World Forum for Harmonization of Vehicle Regulations

Proposal for a new 09 series of amendments to UN Regulation No. 48 (Installation of lighting and light-signalling devices)

Submitted by the Working Party on Lighting and Light-Signalling*

6.2.6.1.2. Vertical inclination limits of the cut-off

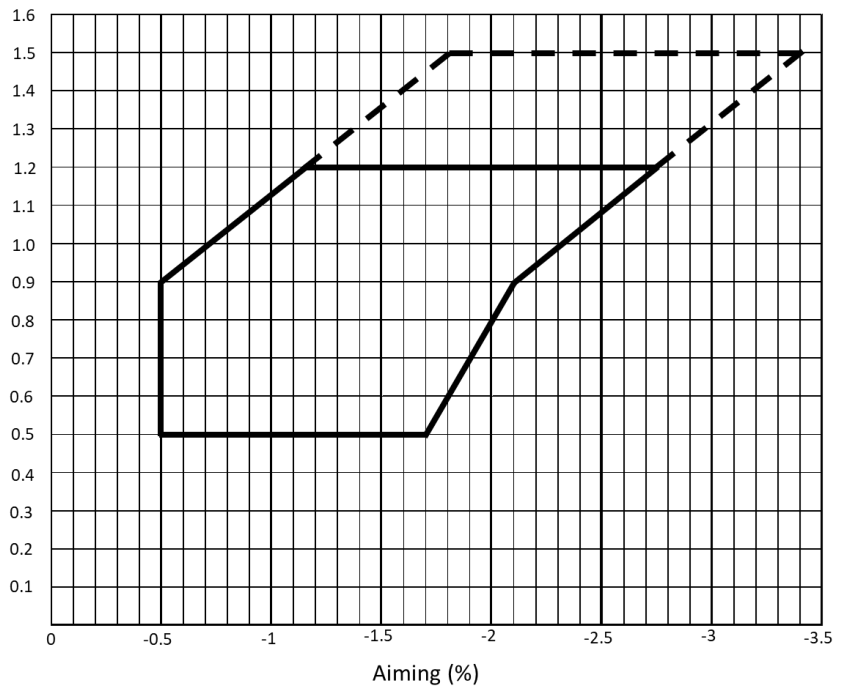
Depending on the mounting height in meters (h) of the lower edge of the apparent surface in the direction of the reference axis of the dipped-beam headlamp, measured on the unladen vehicles, the vertical inclination of the cut-off of the dipped-beam, starting from the initial downward inclination value set by the vehicle manufacturer as prescribed in paragraph 6.2.6.1.1., shall remain between the following limits under all the static loading conditions of Annex 5:

Mounting height h [m]	Upper inclination limit [per cent]	Lower inclination limit [per cent]
$0.5 \leq h \leq 0.9$	-0.50	$-(h + 1.2)$
$0.9 < h \leq 1.2$	$-(h \times 2.17 - 1.45)$	$-(h \times 2.17 + 0.15)$
$1.2 < h \leq 1.5$

The above limits are summarized in the diagram below.

The area within the dashed line indicates the extension of the aiming diagram only valid for M₂G, M₃G, N₂G, N₃G (off-road) vehicles.”

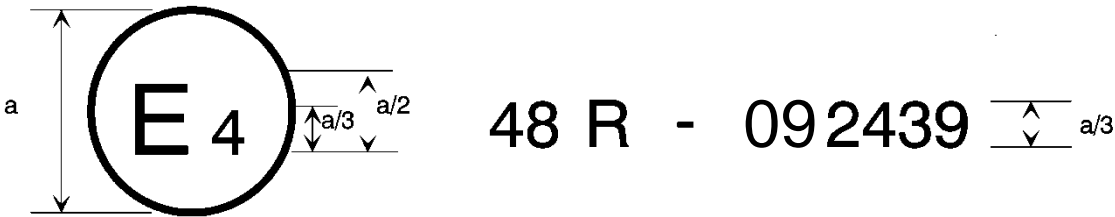
Insert a new item 10.9., to read:

"10.9. Comments regarding answer-back signal (according to paragraphs 6.27.9.1. to 6.27.9.4.):....."

Model A

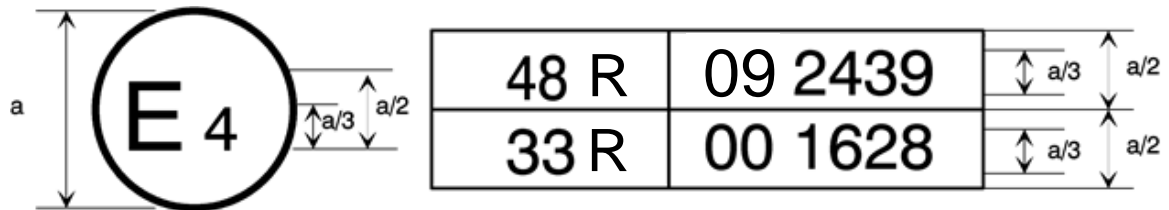
The above approval mark affixed to a vehicle shows that the vehicle type concerned has, with regard to the installation of lighting and light-signalling devices, been approved in the Netherlands (E4) pursuant to UN Regulation No. 48 as amended by the 09 series of amendments. The approval number indicates that the approval was granted in accordance with the requirements of UN Regulation No. 48 as amended by the 09 series of amendments.
